APPLICATION FOR A CERTIFICATE OF APPROPRIATENESS – STAFF REPORT

COA-0068-2019 1204 E LANE STREET

Nature of Project: Construct house with deck; construct garage; install driveway and fence; remove two trees, plant two trees; renew COA for garage demolition

**PROPOSED PLOT PLAN FOR  
SILVER DEVELOPERS, LLC  
WAKE COUNTY, NORTH CAROLINA**

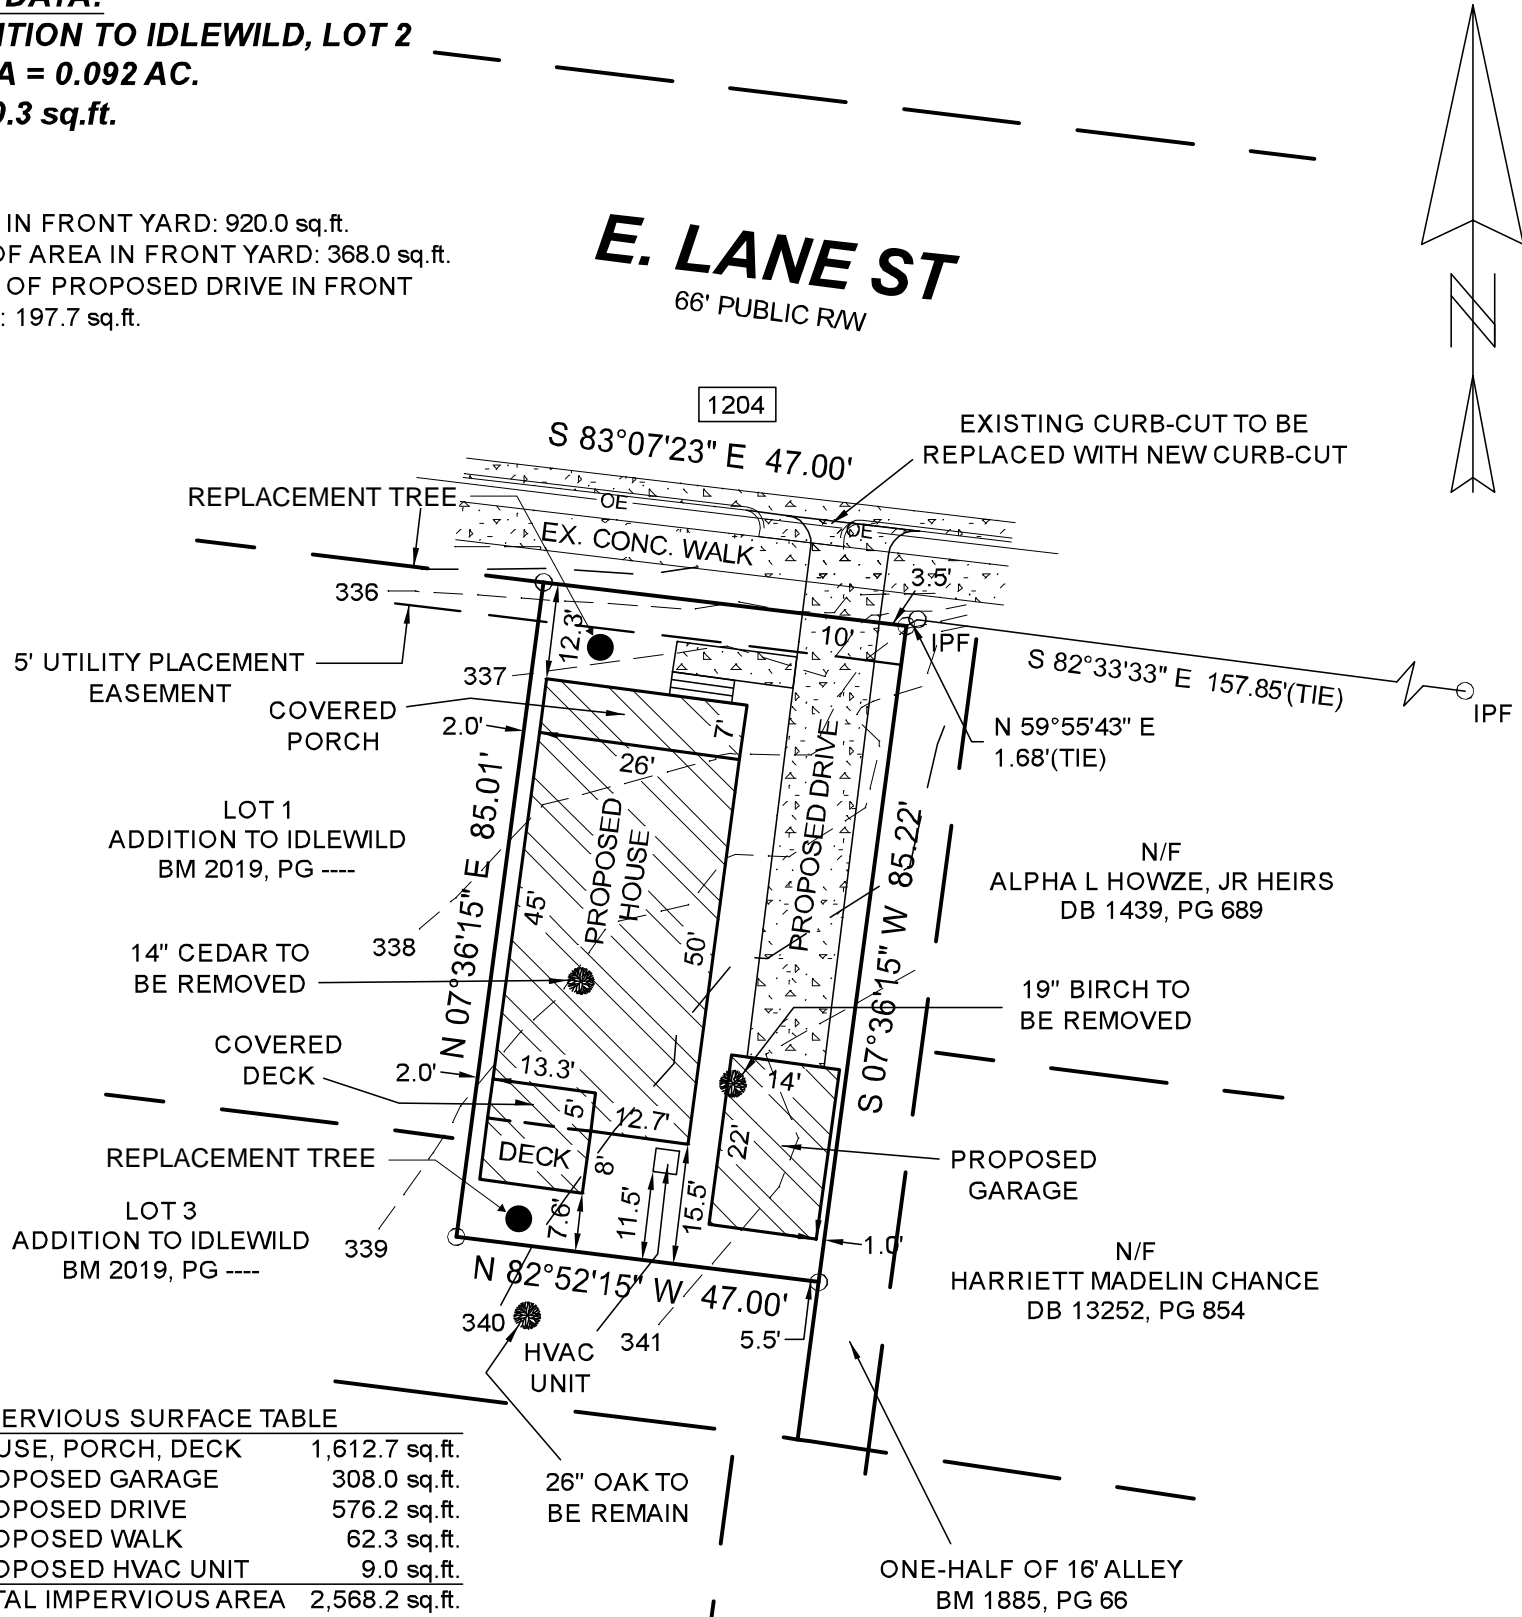
- 5\* The new house is oriented to face E Lane St with a garage in the southeast corner of the lot and a driveway leading to it from the street. There is no indication what material or finish has been proposed for the driveway; a water-washed finish is historically appropriate for concrete driveways.

- 6\* A walkway is shown leading from the driveway to the front porch steps. This is an atypical arrangement for historic properties like the Delany House where the front walkway leads directly from the sidewalk to the front steps.

- 3\* According to the proposed plot plan in the application the proposed setback of the house is 19’. The front porch is approximately 12’ from the sidewalk. The Delany House fronts on N State Street and is setback from E Lane St approximately 6.6’.

- 4\* **Built area to open space analysis:** According to the applicant, the built area which includes the house, deck, porches, driveway and garage is proposed to be 64.2%. As subdivided, the Delany House built area will be 42.4%. The nearby Weaver House, another historic landmark has a built area of 36.7%. It is unclear if the Delany House calculation includes the surface area of the large paved area at the rear of the house.

3. That the driveway have a water-washed finish.

4. That there be a front walkway that leads directly from the sidewalk to the front steps.

**BUILDING COMPARISONS**

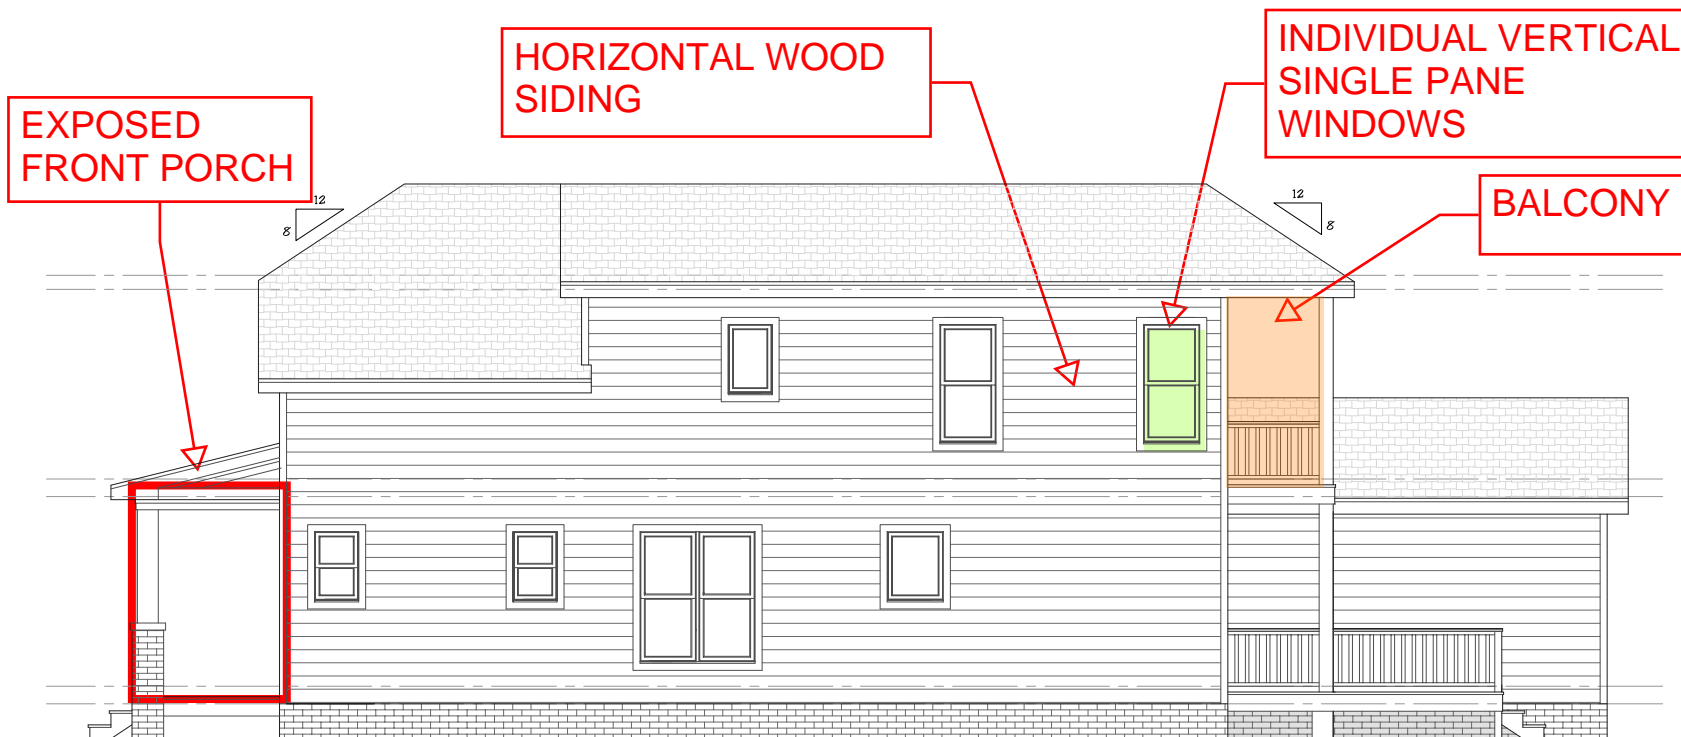
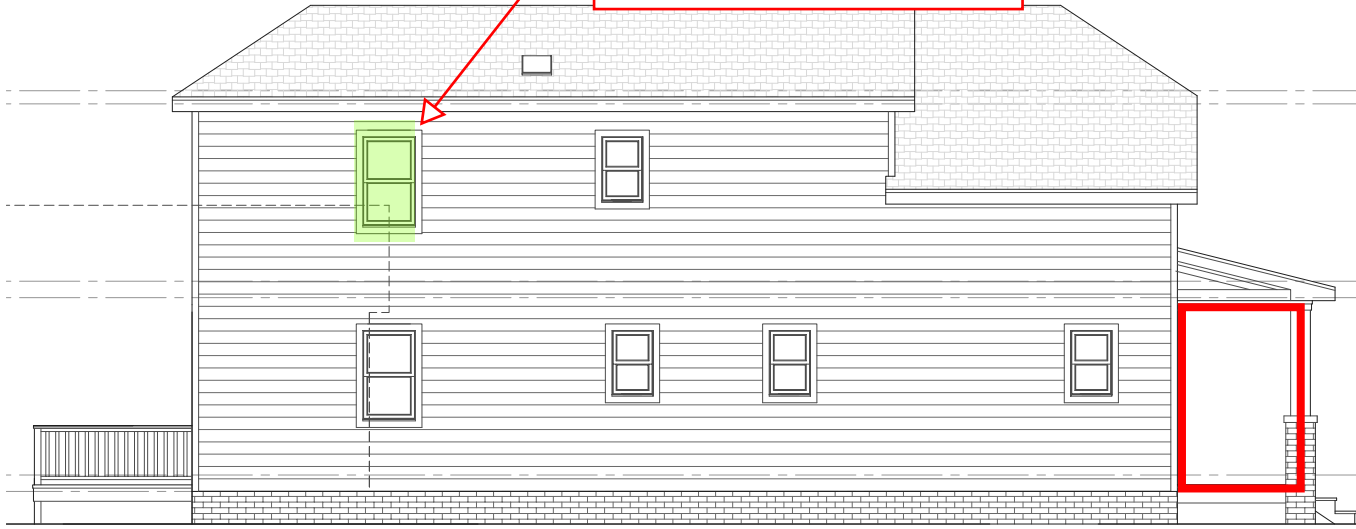
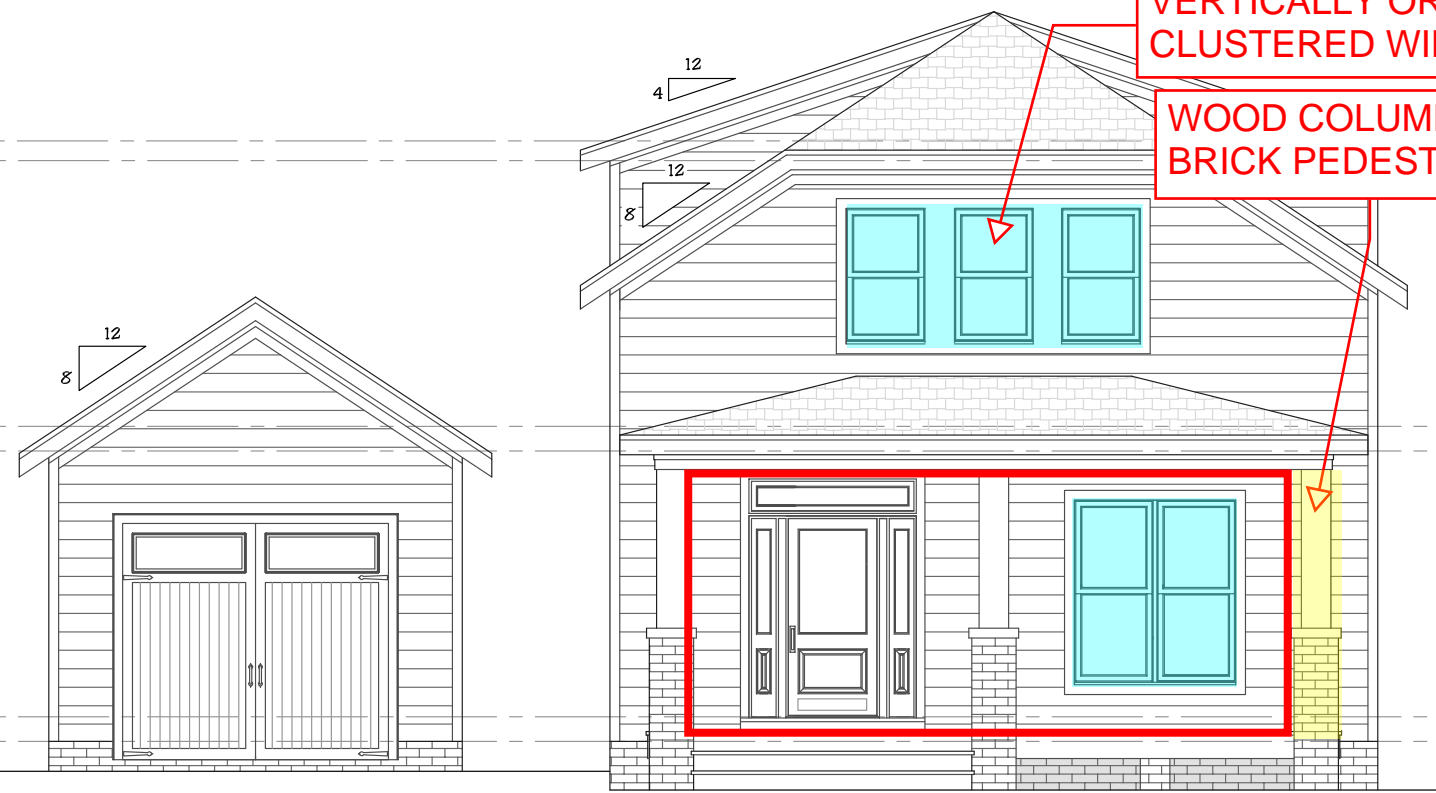
- 8\* The application includes two pages labeled Building Comparisons that shows elements from both the Delany House and the Weaver House across the street that served as references for the development of the proposed design.

**FRONT ELEVATION**  
SCALE: 1/4"=1'-0"

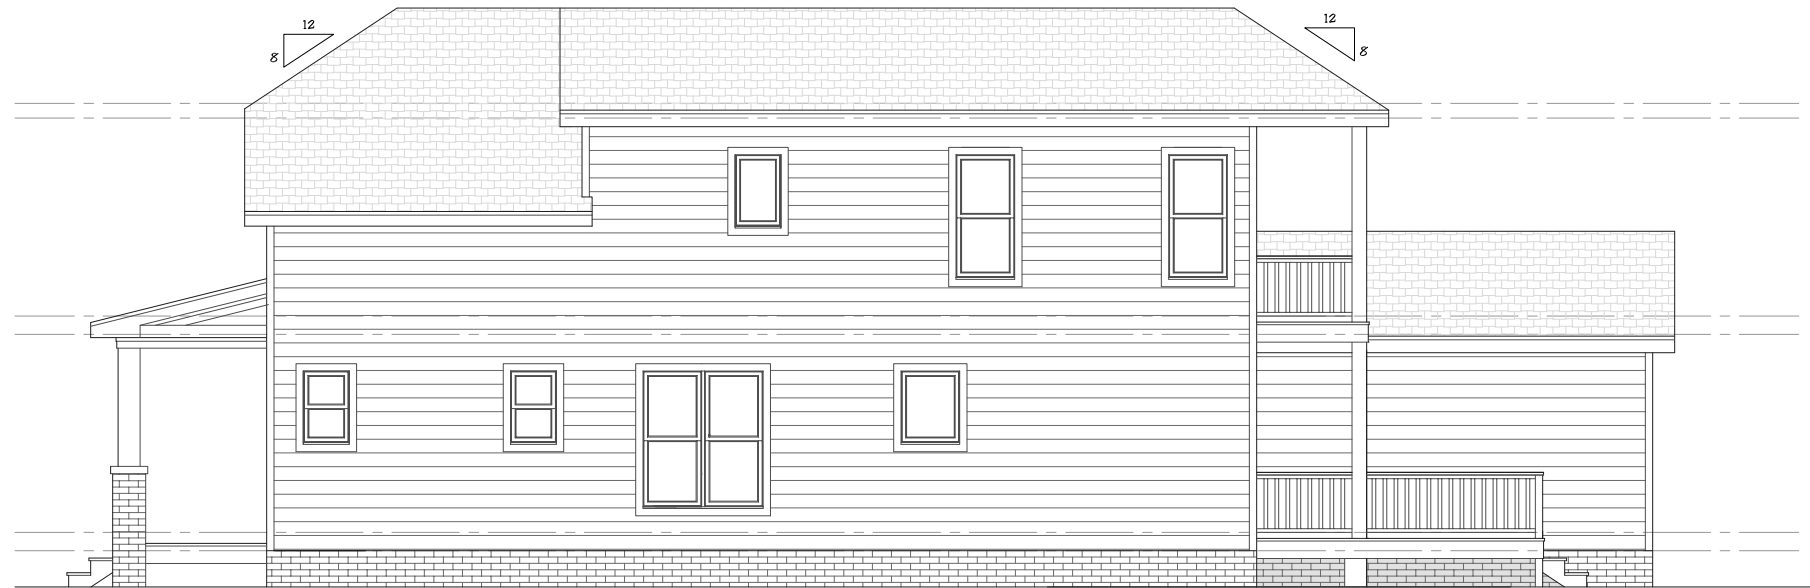
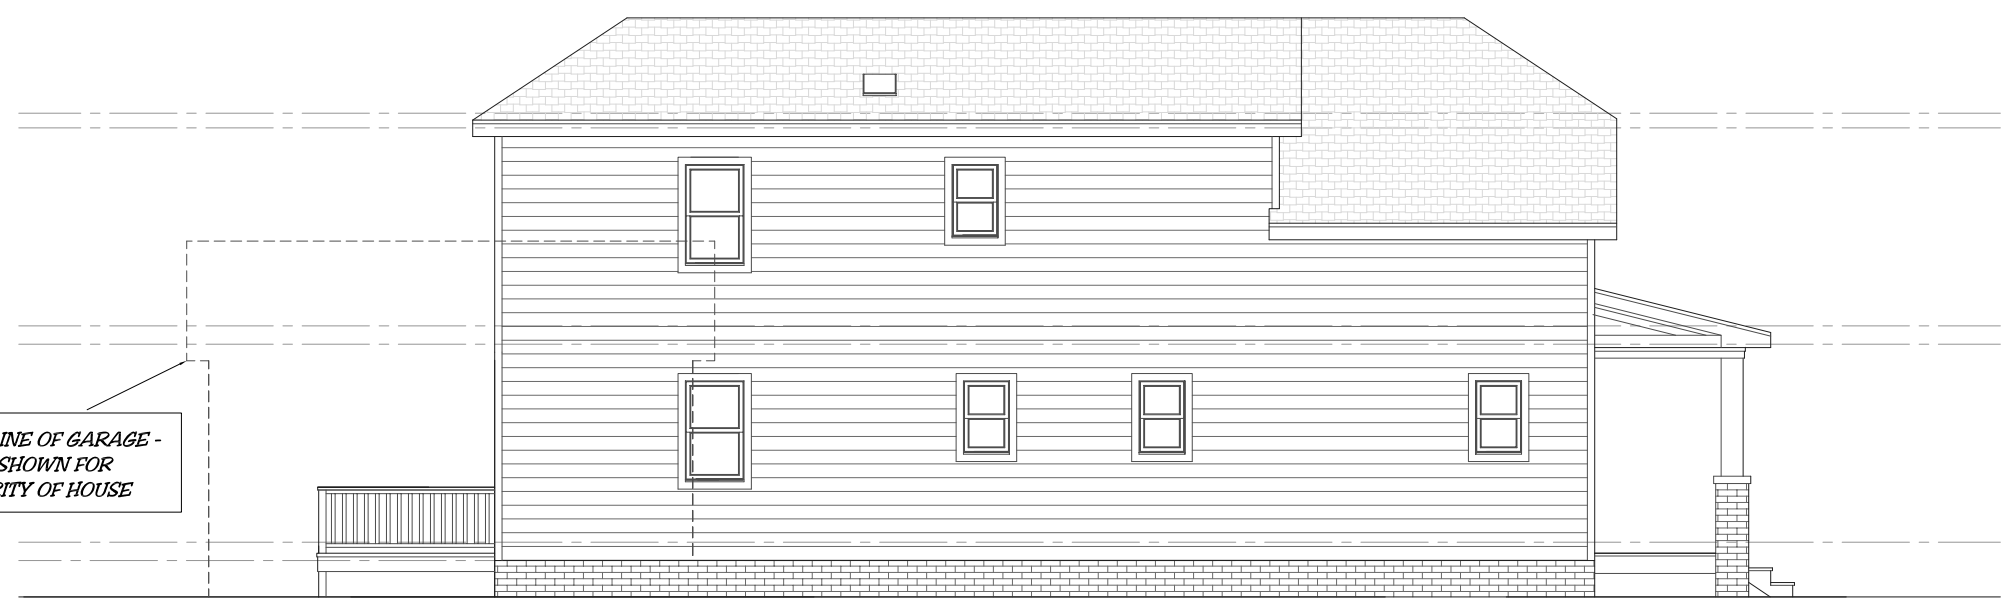
- 6\* The applicant proposes constructing a two-story house with porches in the front and rear as well as a rear deck.
  - 7\* The roof ridge appears to be roughly 26’ and is higher than the nearby Delany House as shown in an elevation drawing on page 12 of the application. The roof ridge on the new

house appears to be approximately 3' higher than the Delany House which is a 1 ½ story residence.

- 9\* The proposed house has a long rectangular form with a clipped gable in the front and hipped roof in the rear. From the front, the house appears to have side dormers. These extend to become a hip which masks the shallow pitch of the rear portion of the roof

- 11\* The house is proposed to be clad with painted smooth-faced fiber cement siding with an 8" exposure which is deeper than the 5-7" exposure typical of historic houses.

- 17\* The window trim is shown to be in a modern picture frame configuration. Historically windows would have trim on three sides with a sill at the bottom.

5. That the smooth-faced fiber cement siding have a 5-7" exposure.

- a. Species and size details for new trees;
  - b. Location and finish color of the fence and gate;
  - c. Roof material;
  - d. Front porch including the roof, floor, ceiling, pier and columns;

- e. Trim at windows and doors including a sill detail on the windows;
  - f. Brick specifications/sample for the color, size and bond pattern;
  - g. Doors, showing both section and elevation views, muntin profiles and material descriptions;
